# UNITED STATES PATENT AND TRADEMARK OFFICE

APPLICATION NO.	FILING DATE	FIRST NAMED INVENTOR	ATTORNEY DOCKET NO.	CONFIRMATION NO.
09/980,659	04/04/2002	Atsunobu Sakamoto	0112895-005	6654
40337	7590	10/11/2005	EXAMINER	
NANCY A. PAPPAS 15210 AMBERLY DRIVE #1826 TAMPA, FL 33647			JEFFERY, JOHN A	
			ART UNIT	PAPER NUMBER
			3742

<b>Office Action Summary</b>	<b>Application No.</b> 09/980,659	<b>Applicant(s)</b> SAKAMOTO ET AL.	
	<b>Examiner</b> John A. Jeffery	<b>Art Unit</b> 3742

## **DETAILED ACTION**

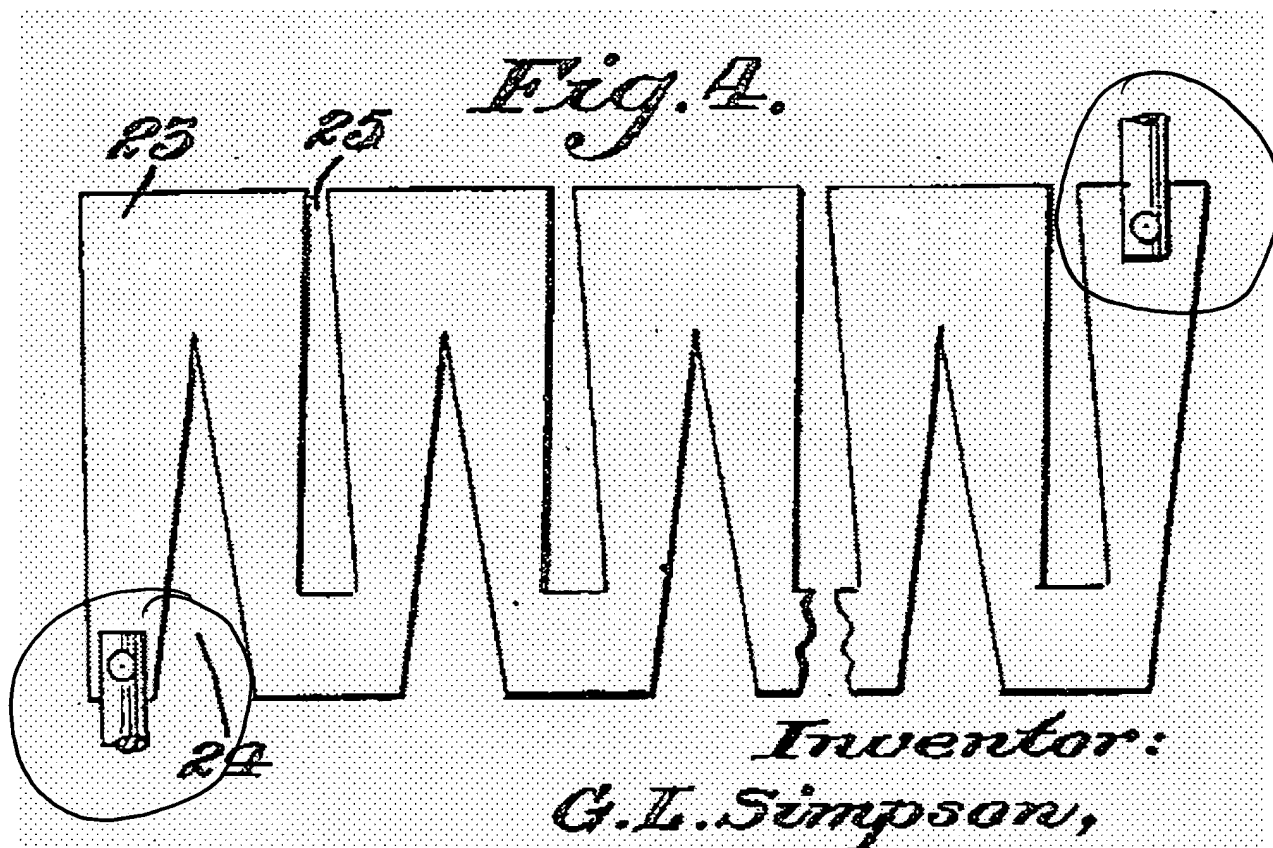
Claims 2, 7-11, 14, and 15 are rejected under 35 U.S.C. 103(a) as being unpatentable over Kettelhoit et al. (US 4,790,901) in view of Simpson (US 1,975,410). The claims differ from Kettelhoit et al. (US 4,790,901) in calling for asymmetrical electrode portions. But asymmetrical electrode portions in electric heaters is well known in the art. Simpson (US 1,975,410), for example, discloses providing electrode portions for a serpentine electric heater 25 with unequally sized electrode portions. Compare the left electrode portion with the right electrode portion in Fig. 4 of Simpson (US 1,975,410), reproduced below for clarity:

Such an arrangement produces a non-uniform heating profile along the heater thus compensating for temperature non-uniformities during operation. See Page 2, lines 26-48. In view of Simpson (US 1,975,410), it would have been obvious to one of ordinary skill in the art at the time of the invention to provide unequally sized electrode portions in the heater of the previously described apparatus to produce a non-uniform heating profile along the heater thus compensating for temperature non-uniformities during operation.
